Pre-lodgement Meeting Notes

Application No: PLM2021/0314
Meeting Date: 2 December 2021
Property Address: 120 Prince Alfred Parade NEWPORT
Proposal: Subdivision, demolition and construction of two dwellings
Attendees for Council: Lashta Haidari – Principle Planner
Ellie Peedom – Planning Officer

Figure 1. Height control variation as shown on dwg. Section A - No 120.

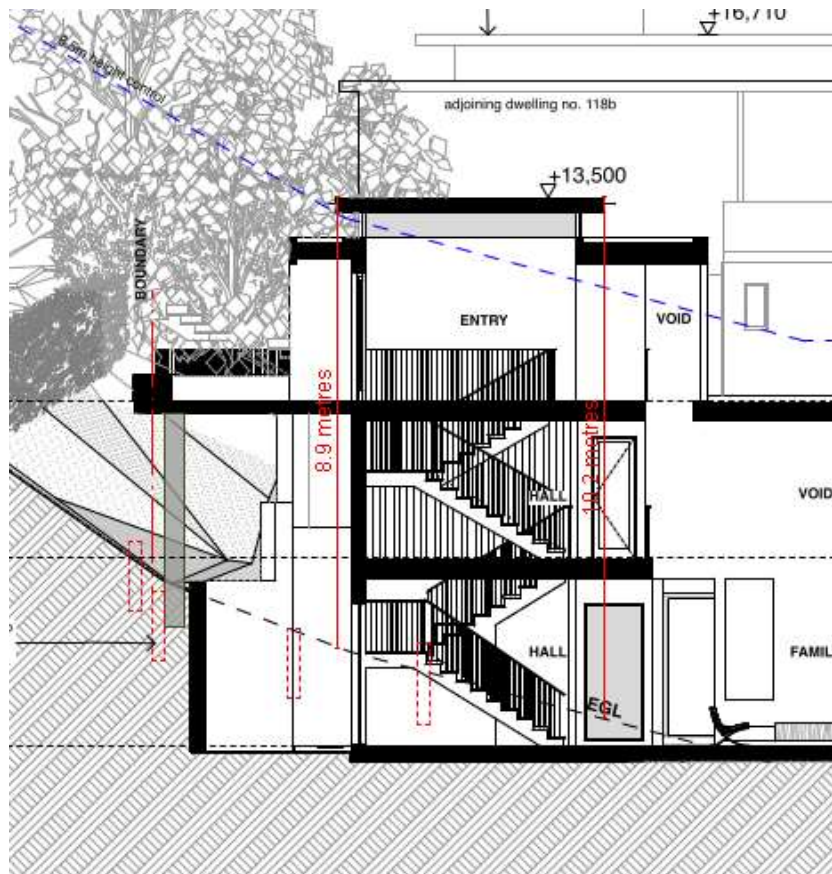
The proposed structure at 120 breaches the height control as shown below in Figure 1.

The height breach of approx... 1.75m enables the development at 120 to achieve 3 storeys in height, mirroring the scale of the adjacent property to the west. It is understood that this layout is an outcome due to the shape of the site (the portion behind the Foreshore Building Line) as well as higher street level access in comparison to 120A, which may or may not necessitate vehicular access from this proposed third storey. Therefore, it must be demonstrated by the applicant in a Clause 4.6 assessment that this variation to the development standard is necessary to achieve amenity, as well as why design alternatives below the height threshold are not feasible. The following objective of this clause is considered critical to the assessment:

It is noted in the preliminary report provided by the applicant for this meeting that clause 4.3 (2A) will be drawn upon for this assessment, however, site 120 is not identified on Councils Flood Hazard Map nor Coastal Risk Map. Only site 120A is proposed to be in flood affected area. Therefore, to draw on this clause additional information from a flood engineer may be necessary.

This variation is considered extensive, and the query stands as to whether or not the clear storey over the entrance can be omitted in the design to avoid the structure coming in to the

south west corner. The applicant will need to thoroughly demonstrate the need for this variation and how it achieves the outcomes of the control.

Figure 2: Terrace roof overhang beyond foreshore building line as shown on dwg. Section B- No 120a.

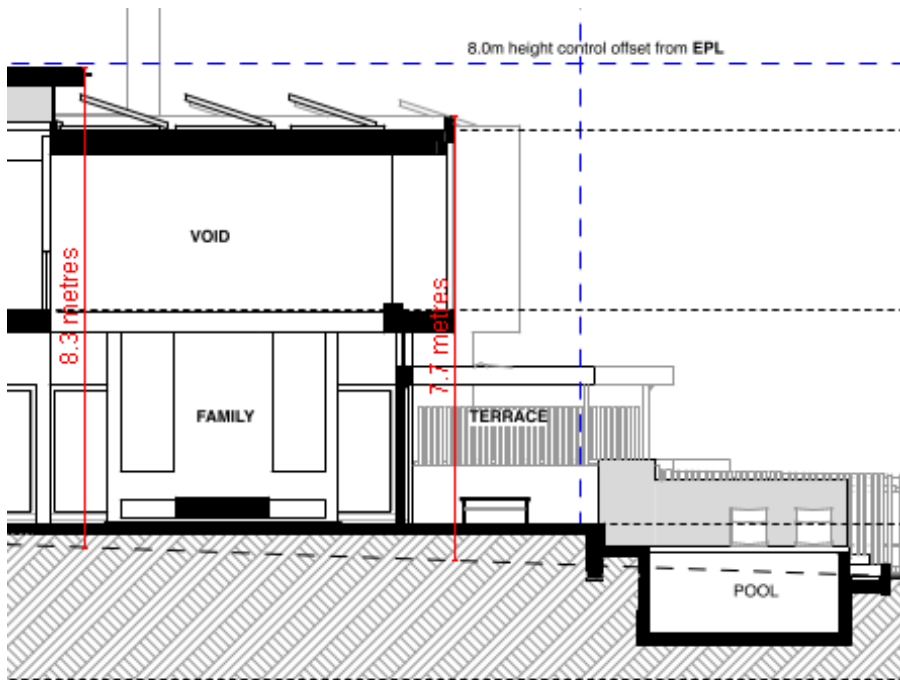
Despite outdoor recreation facilities being conditionally permitted beyond the FBL, the terrace roof in this proposal is attached to the dwelling and could be interpreted as the dwelling extending beyond the FBL which is a prohibited development. See Figure 2 below:

Therefore it must be clearly demonstrated by the applicant that the structure is solely for the purpose of a recreation facility (outdoor) and will not in turn enable the applicant to apply for future development consent to enclose, extend or alter the area under clause (2)(a) of this principle development standard.

Figure 3. Building envelope breach as shown on dwg. 120a Eastern Elevation

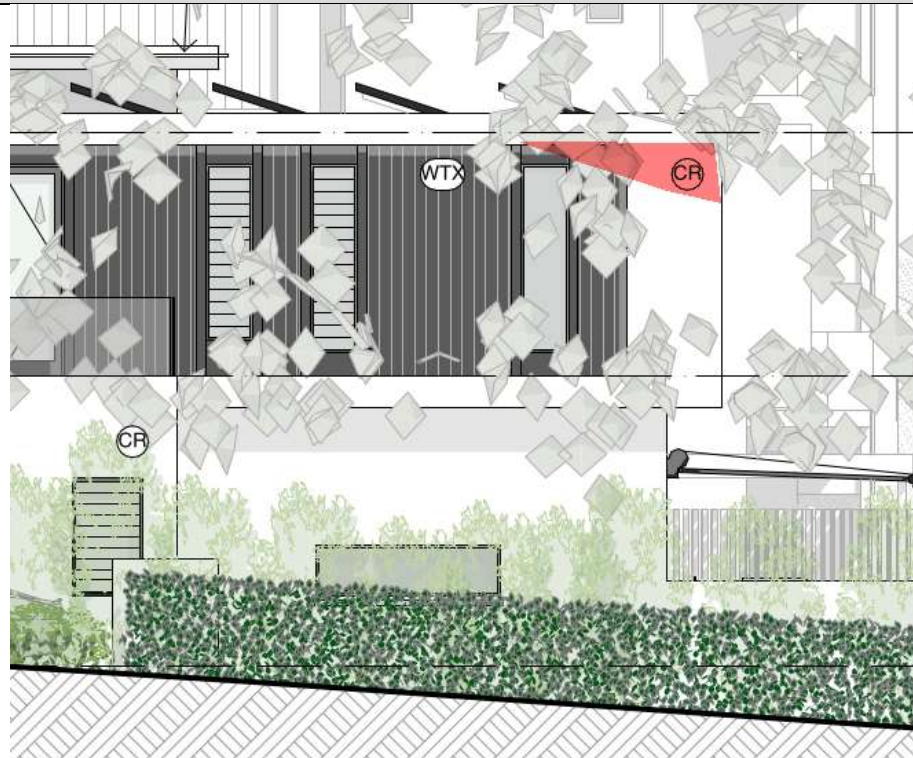
D10.7 Front building line (excluding Newport Commercial Centre)	6.5 or established building line, whichever is the greater.	Established building line (min 0.7m)
The proposal for a minimal front setback is considered in keeping with the adjoining properties to the west		
D10.8 Side and rear building line (excluding Newport Commercial Centre)	2.5 to at least one side; 1.0 for other side 6.5 rear (other than where the foreshore building line applies)	Compliant
Please refer to C1.3 View Sharing above for comments.		
D10.11 Building envelope (excluding Newport Commercial Centre)	45 degrees from a height of 4.2 metres above ground level (existing) at the side boundaries to the maximum building height	Maximum 11% breach at 2.5m length of building.
The proposed structure at 120A breaches the building envelope control generally as shown in Figure 3.

The proposed breach is considered minor in nature. However, it does play into broader issues around the physical separation of the two buildings as well as bulk and scale. The breach could be accepted subject to other design amendments occurring to mitigate these two issues as well as the applicant's ability to demonstrate that the proposal achieves the outcomes of the control.
